Determination 2023/001

Regarding the compliance of particular elements of a swimming pool barrier

409 Hill Street, Thames

Figure 2: Site drawing (not to scale)

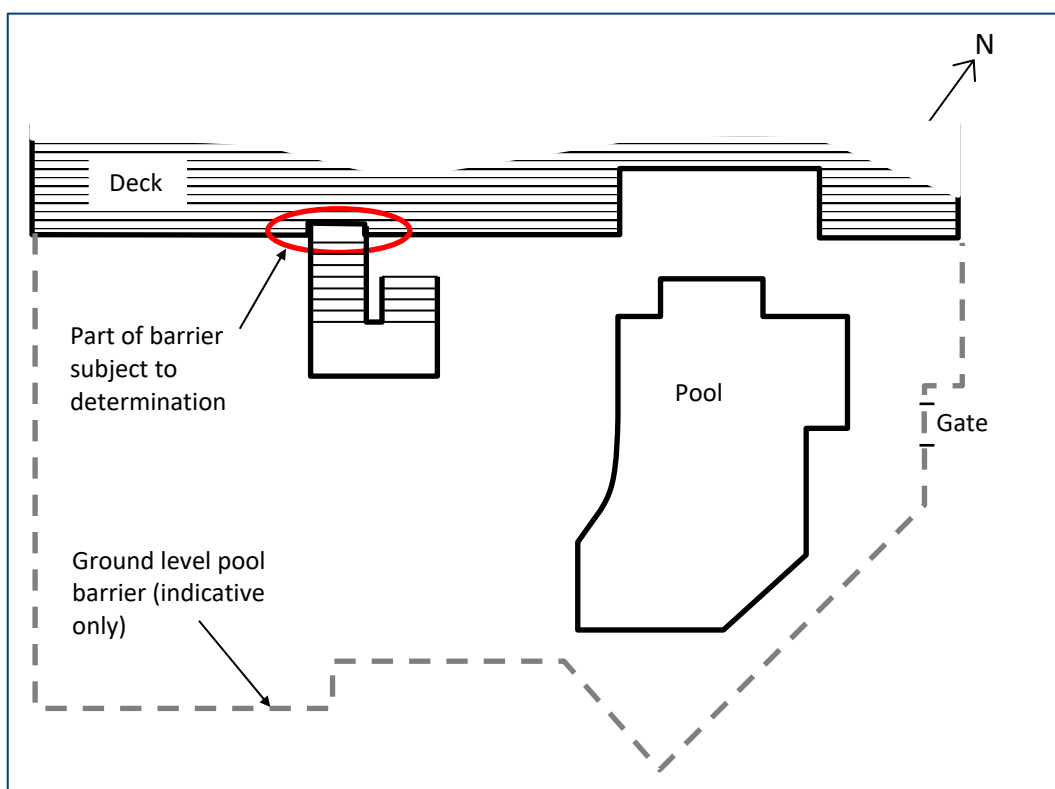
- 2.4. The gate is 1055mm high from the floor level of the deck and is constructed with vertical metal bars. The gate is self-closing with a spring loaded closer. The latch release for the gate is 1400mm above the floor level of the deck.

- 2.5. The gate is slightly set back from plane of the glass balustrade. Short sections of metal fencing on each side of the gate connect the gate to the glass balustrade. These sections are the same height as the glass balustrade (ie they are 1000mm high from the floor level of the deck).

- 2.9. In a letter to the owner dated 6 June 2019, the authority requested that the gate, and the sections of balustrade within 1200mm of each side of the gate, be raised to a height of 1200mm, and the latch/locking device be raised to 1500mm.

Figure 3: Drawing of projections within 1200mm

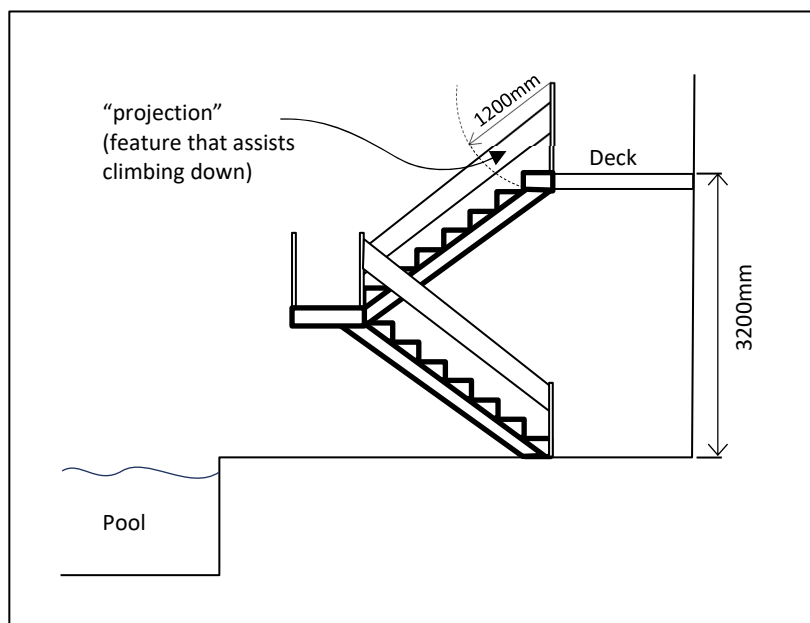
4.26.2. the handrails on the staircase are projections within 1200mm of the top of the gate and sections of balustrade either side, and could assist a child to climb down; as such, they do not come within the specifications in paragraph 2.5.2 of the Acceptable Solution (see Figure 6)

Figure 3(d) as appears in Acceptable Solution F9/AS1

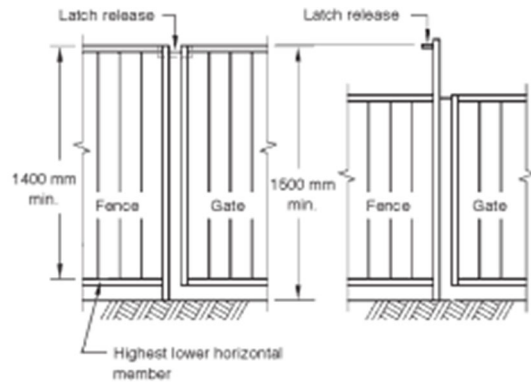
4.26.5. the latch on the gate does not comply because it is lower than the minimum height of 1500mm (as specified in paragraph 3.1.2 of the Acceptable Solution).

- 4.38. The latch release on the gate is lower than the minimum height specified in the compliance documents and standards referred to above. I note a latch release of 1400mm high is easier for children under 5 years of age to reach and operate than a latch release of 1500mm high. For the latch on the gate to comply as an alternative solution, I am of the view that the difficulty of either reaching or operating the latch (or both) would need to be greater to compensate for the lower height. I do not see any unique feature or features associated with the latch that compensate for the lower height. That being so, I find that the latch on the gate can be readily opened by children and, as such, it does not comply with Clause F9 of the Building Code as an alternative solution.
